# Staff Summary Report

**SUBJECT:** Hold a public meeting for a Development Plan Review for TEMPE DODGE, located at 7975 South Autoplex Loop.

**DPR10086** – Development Plan Review including site plan, building elevations, and landscape plan.

**WEST ELEVATION**

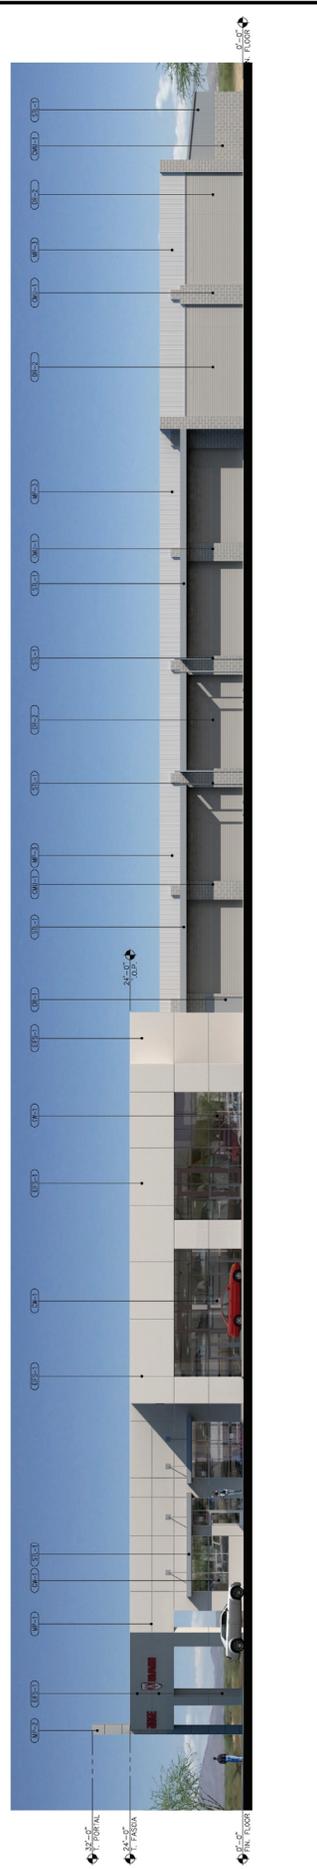
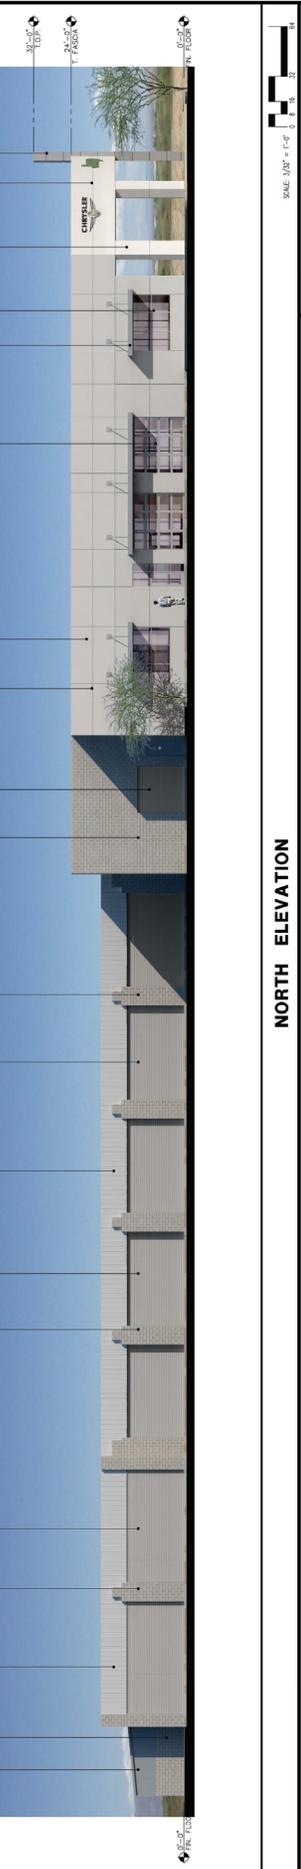
12. The materials and colors as presented are as follows:
  - a. Exterior Plaster (EIFS) color –Benjamin Moore – Sto Oyster 21612
  - b. Aluminum Composite Panel –Silver Metallic – ALPOLIC MTLC BSX ALUMINUM
  - c. Aluminum Composite Panel Accent –hairline high polished – ALPOLIC DM HLA ALUMINUM
  - d. Glazed Storefront & Frame, Overhead Sectional Door – clear glass & clear anodized aluminum frame
  - e. Metal Shading Device, Existing Steel Canopy Framing, Hollow Metal Door and Frame, Existing Overhead Doors – Dunn Edwards DE6382
  - f. Existing Metal Panel Treatment above Service Bays – Dunn Edwards Q11-31P
  - g. Existing CMU color – Benjamin Moore – Pelican Gray P61612

Provide main colors and materials with a light reflectance value (LRV) of 75 percent or less. Specific colors and materials exhibited on the materials sample board are approved, subject to compliance to the maximum LRV requirement. The aluminum panels at the millennial arch and the hairline trim at the spandrel are considered accents and are exempt from the maximum LRV requirement. Submit any additions or modifications for review during building plan check.

13. Provide secure roof access from the interior of the building. Do not expose roof access to public view.
14. Conceal roof drainage system within the building wall. Minimize visible, external features, such as roof drain overflow scuppers, and where needed confine these to the roof line and the base of the building. Do not expose roof drain leaders.

27. Provide address signs on building "A" at the following locations where these have not already been done: on the east elevation near the southeast corner, on the south elevation of the addition near the southwest corner, and on the curving spandrel west elevation near the northwest corner. Conform to the following for building address signs:

CONCEPTUAL PLANTING PLAN

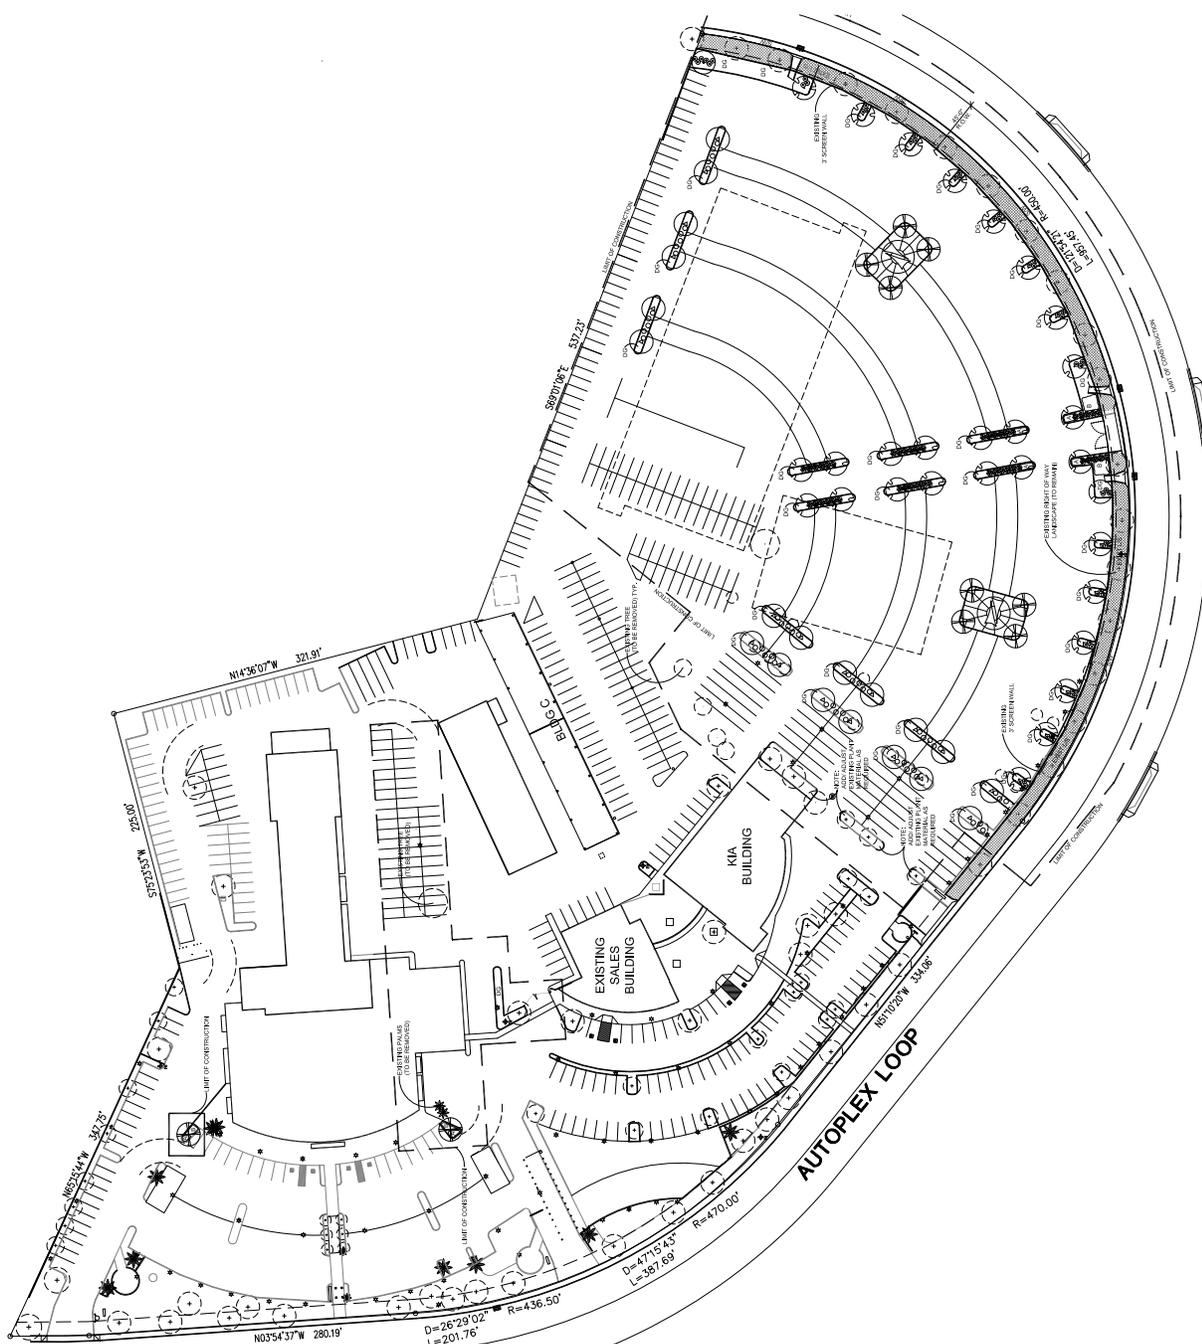
18. Indicate outline of retention basins, sub-grade retention structures and other sub-grade utility structures (if any) and outline of

public and private utility easements on landscape plan.

19. Indicate locations of freestanding light poles on landscape plan to assist with tree / light coordination.
20. The plant palate is approved as proposed and specified on the landscape plan, but is subject to the requirement for natural mature height of shrubs and groundcovers in proximity of pedestrian and paving areas. Any additions or modifications may be submitted for review during building plan check process.

21. With the landscape and irrigation construction documents, include an existing plant inventory plan indicating the approximate location and size of existing trees, shrubs, groundcovers and accents to remain. Identify each specimen to remain by species, approximate size including (for trees) caliper, height and foliage width and (for other plants) height and width. The inventory of existing plants may be part of the landscape plan or may be a separate document.
